REVIEWER #3: 1. Quantity and quality of the measurements: Spatial representativeness and significance of the statistical analysis

AUTHOR RESPONSE: In the discussion of individual points below we address these topics:

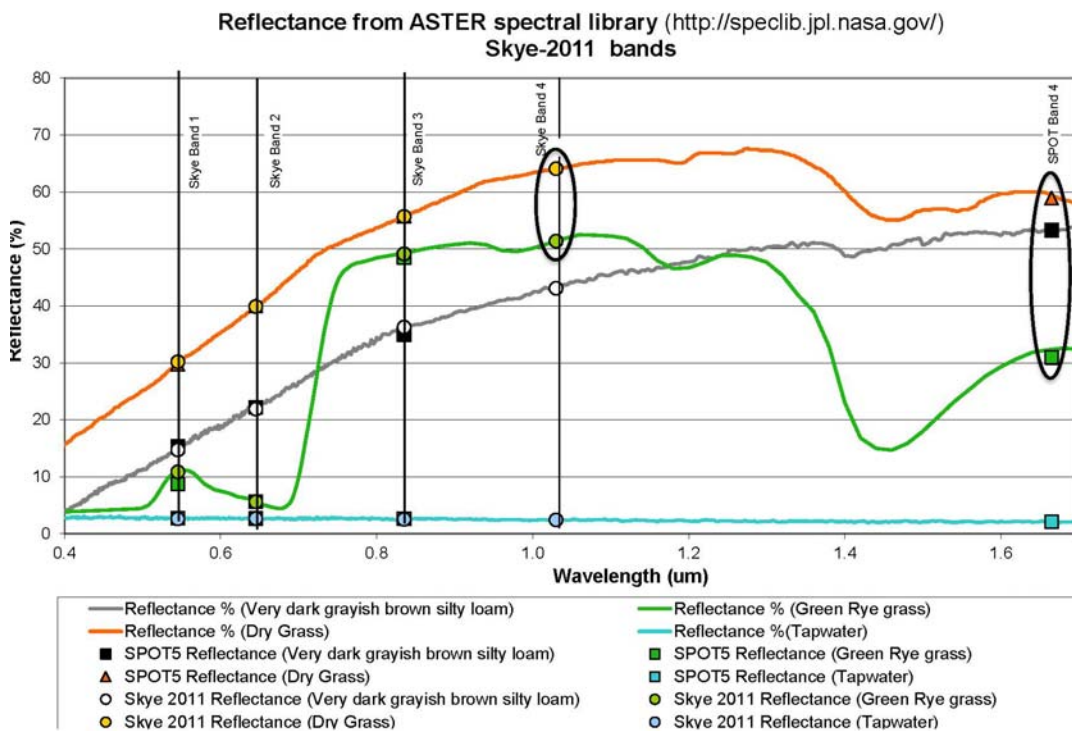
REVIEWER #3: PAGE 18015 Same page line 20. Was the FOV verified/characterized by the authors before sensor deployment. If not, it would be convenient to explicit that FOV is 25 degrees “as indicated by the manufacturer” considering that published works have demonstrated that some sensor FOVs greatly differ from manufacturers specifications. See the work of MacArthur, A.; MacLellan, C.J.; Malthus, T., "The Fields of View and Directional Response Functions of Two Field Spectroradiometers," in *Geoscience and Remote Sensing, IEEE Transactions on*, vol.50, no.10, pp.3892-3907, Oct. 2012 In general, all information about instrument calibration/characterization before its deployment in the field is quite useful and should be explained.

AUTHOR RESPONSE: We did not test the FOV of the sensors before deployment given that the sensors were calibrated individually by Skye and created to our specifications. This should be clarified in the text however, to add the suggested “as indicated by the manufacturer”.

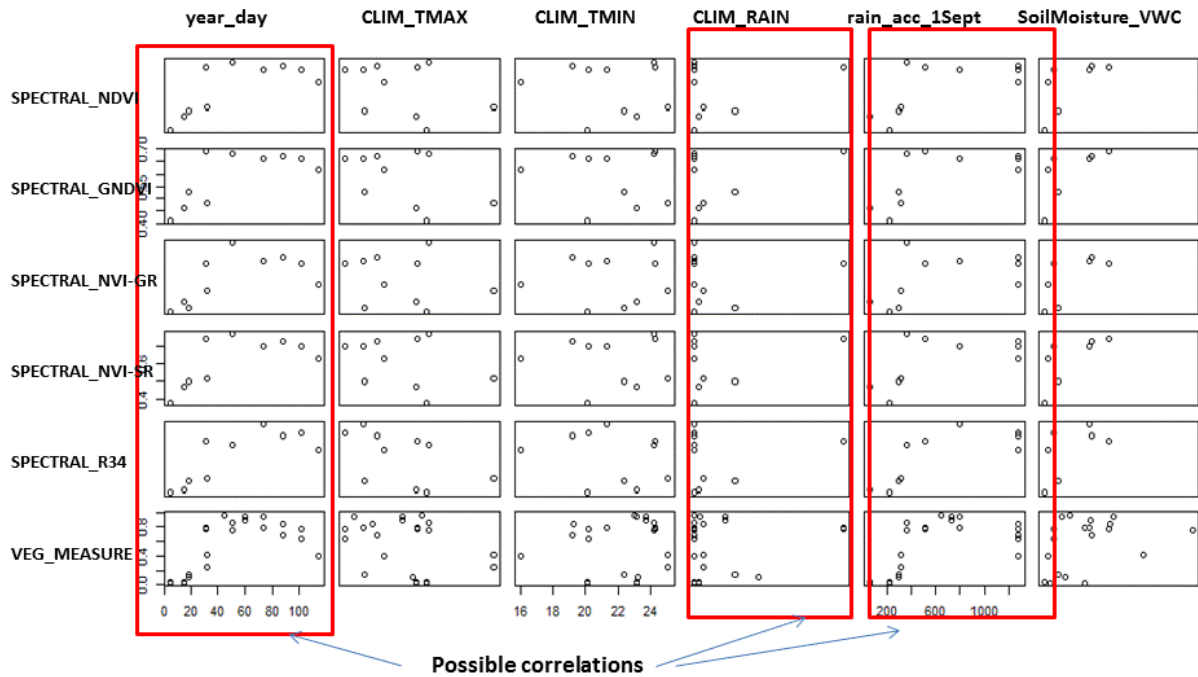
REVIEWER #3: PAGE 18020 Same page lines 23-24. In my opinion this is one weak point in the statistical analysis. Collinearity analysis should be done as this could affect not only to the indices but also to other input data which has been combined in the regression as is the case of weather data, soil moisture and spectral indices. In fact, authors recognize that “soil moisture sensors. . . showed a strong correlation with the average of precipitation recorded at the CTA and TA stations” (page 18013).

AUTHOR RESPONSE: The reviewer is correct in that there is likely to be a correlation between variables such as weather data, or between more than one vegetation indices. It was for avoid this problem of collinearity that the authors controlled the number and type of variables in the model development by:

As part of addressing the reviewer’s comment we re-visited our initial exploratory analysis including the scatterplots and correlation matrix (see below).

In the revised manuscript we therefore will remove the subset of the 2-variable models that show this high correlation, and change the results discussion, tables, etc. to reflect this. This change will not impact on the most important relationships discussed in the paper, which are the single variable relationships between the sensor and field measurements.
